**SUBJECT:** Chief Engineer's  
Directive – ATMS and  
ASDS Interim  
Addenda

**Interim Addendum to 2016 ATMS – approved by FHWA 5/18/2022, published for use 6/3/2022**

**Section 2H.100 Project Information Signs (I-240)**

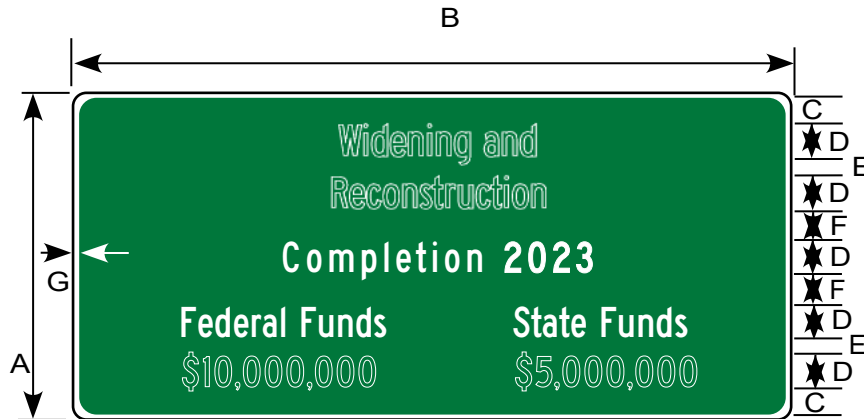
Section or Sign Number	Section Title / Sign Subject	Summary of change
2H.100	Project Information Signs (I-240)	Add Section 2H.100 to allow use of new sign I-240 displaying project funding and duration.
I-240	Project information sign detail	Add new sign I-240 to ASDS, for use according to new section 2H.100 to the ATMS.

02 **If used, the PROJECT INFORMATION SIGN (I-240) shall only be installed on projects with basic bid amounts of \$15 million or greater and having a duration of at least 70 workings days, when holidays and Saturdays are counted.**

03 **Project information signs shall not be installed prior to the commencement of work or be used to provide advance notification of road work that will begin at some future date. Project information signs shall be removed when the project reaches substantial completion.**

04 **Project information signs shall be limited to one per direction of travel on the roadway on which the project is based for projects greater than one mile in length. Projects less than one mile in length shall have one Project Information sign installed facing the direction of the highest average daily traffic. Project information signs shall not be installed on projects where there are two or more distinctly separate work areas.**

05 **Project information signs shall not be placed at key decision points where they may interfere with traffic control devices, roadway geometry, or traffic conditions.**

06 **Project information signs shall include the following information:**

1. **Project name or location with work description**
2. **Total dollar amount of Phase 4 and Phase 7, broken out into federal and state funds rounded to the nearest million**
3. **Expected completion year based on bid documents**

Border and Legend: White  
 Background: Green

\*A 3.5" margin shall be maintained on either side of the name and/or funding sources.
